Item Name: Fwd Crosstube - High 407

DART AEROSPACE LTD	Work Order: 162007
Description: Crosstube High Fwd (407)	Part Number: D407-667-105
Inspection Dwg: D407-667-145 Rev: C	Page 1 of 1

DRAWING NO. D407-667-145	TITLE CROSSTUBE ASS'Y (407 HIGH FWD)	REV. C	DART AEROSPACE LTD ENGINEERING ORDER		D.E.O. NO. D407-667-145-C-1	SHEET NO. SHEET 1 OF 1	SCALE NTS
DRAWN <i>q</i>	CHECKED <i>BS</i>	MFG. APPR. <i>BS</i>	APPROVED <i>WD</i>		DE APPR. <i>##</i>		
DATE 11.07.15	DATE 11.07.22	DATE 11.07.22	DATE 11/07/22		DATE 11.07.21

DRAWING NO. D407-667-145	TITLE CROSSTUBE ASS'Y (407 HIGH FWD)	REV. C	DART AEROSPACE LTD ENGINEERING ORDER	D.E.O. NO. D407-667-145-C-2	SHEET NO. SHEET 1 OF 1	SCALE NTS
DRAWN AJS	CHECKED	MFG. APPR.	APPROVED	DE APPR.		
DATE 12.08.02	DATE 12.08.02	DATE 12.08.02	DATE 12.08.02	DATE 12.08.02	DATE 12.08.02

DETAIL P
BONDING STRAP INSTALLATION 2 PL

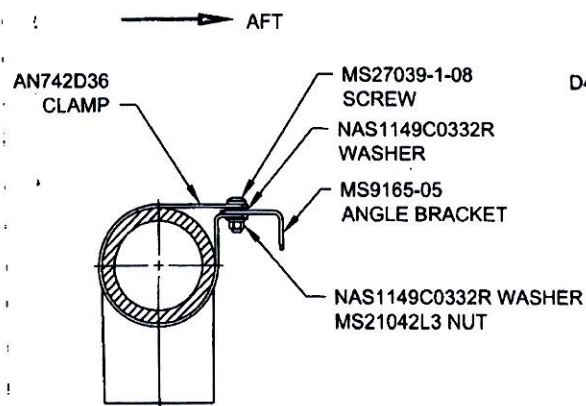
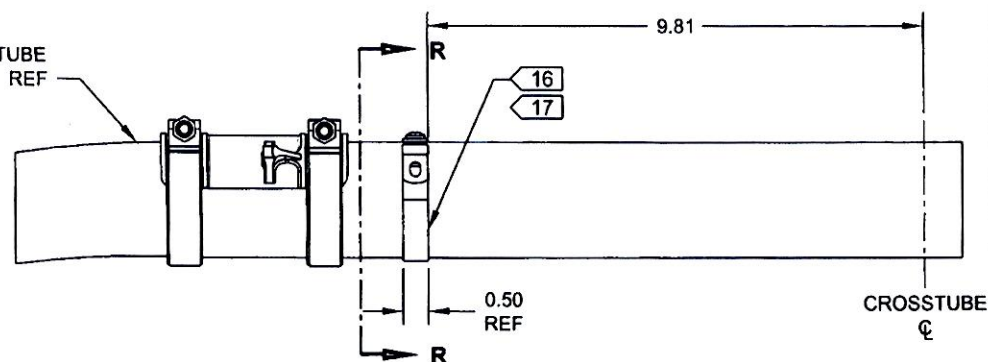
ADD ELECTRICAL GROUNDING STRAP

ITEM	QTY	PART NUMBER	DESCRIPTION
1	X	D407-667-145	CROSSTUBE ASSEMBLY (407 HIGH FWD)
10	2	AN742D36	CLAMP
11	2	MS9165-05	ANGLE BRACKET
12	2	MS21042L3	NUT (OR MS21042-3)
13	2	MS27039-1-08	SCREW
14	4	NAS1149C0332R	WASHER (OR AN960C10L)
